# **Intel® Mobile Celeron™ Processor at 550 MHz, 500 MHz, 450 MHz, and 400A MHz Specification Update**

Release Date: May 2000

Order Number: 245421-004

Figure 6. BCLK Timing Waveform

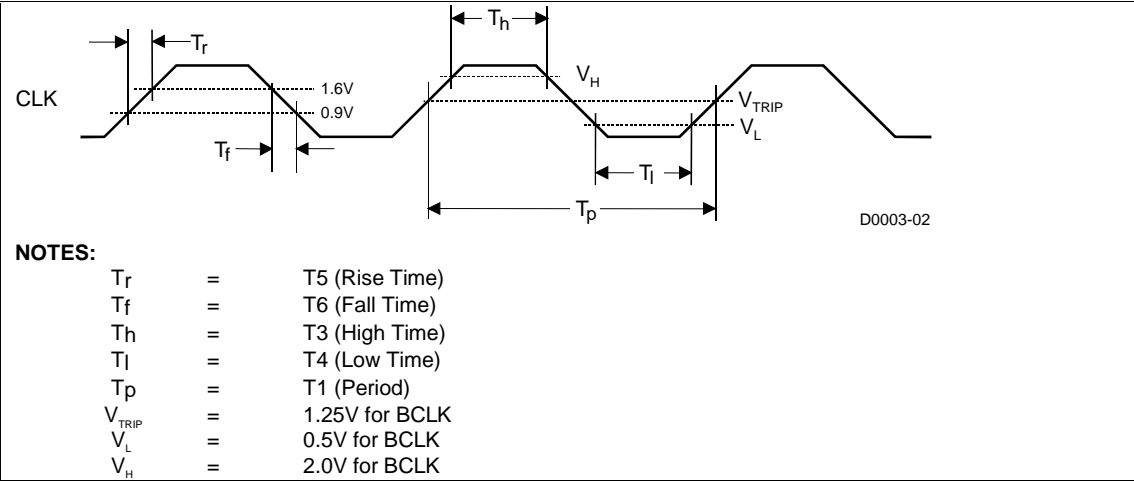
For B0 step processors, the  $V_{IH,BCLK}$  Min spec is changed to 2.0V (from 1.7V for A2 step) and  $V_{IL,BCLK}$  Max spec is changed to 0.5V (from 0.7V for A2 step). Due to this, new values are specified for BCLK high and low times for B0 step processors. These modifications affect corresponding specs in Table 12, Table 13, Table 22, and Figure 6 in *Mobile Celeron™ Processor in BGA2 and Micro-PGA2 Packages at 500 MHz, 450 MHz, and 400A MHz* datasheet.

The following tables and figures highlight the above mentioned BSEL[1:0] and BCLK specs modifications made for B0 step processors:

Symbol	Parameter	Min	Typ	Max	Unit	Figure	Notes
	System Bus Frequency		100		MHz		
T1	BCLK Period		10		ns	Figure 6	Note 2
T2	BCLK Period Stability			$\pm 250$	ps		Notes 3, 4
T3	BCLK High Time	2.70			ns	Figure 6	at >2.0V
T4	BCLK Low Time	2.45			ns	Figure 6	at <0.5V
T5	BCLK Rise Time	0.175		0.875	ns	Figure 6	(0.9V – 1.6V)
T6	BCLK Fall Time	0.175		0.875	ns	Figure 6	(1.6V – 0.9V)

Figure 4. BCLK Waveform at the Processor Core Pins

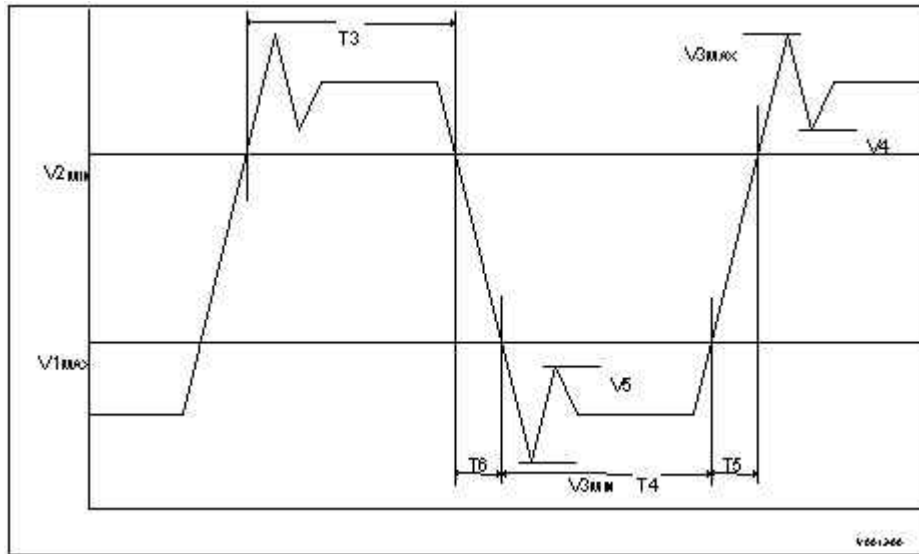
In Table 18, “BCLK Signal Quality AC Specifications at the Processor Core” of the *Intel® Celeron™ Processor Mobile Module: Mobile Module Connector 2 (MMC-2) at 500 MHz and 450 MHz Datasheet*, Note 3 has changed. Figure 4 “BCLK Waveform at the Processor Core Pins” has also been updated. See below.

3. The rising edge ringback voltage specified is the minimum absolute voltage that the BCLK signal can dip back to after the BCLK signal passes the  $V_{IH,BCLK,MIN}$  (rising) voltage limits. The falling edge ringback voltage specified is the maximum absolute voltage that the BCLK signal can dip back to after the BCLK signal passes the  $V_{IL,BCLK,MAX}$  (falling) voltage limits.
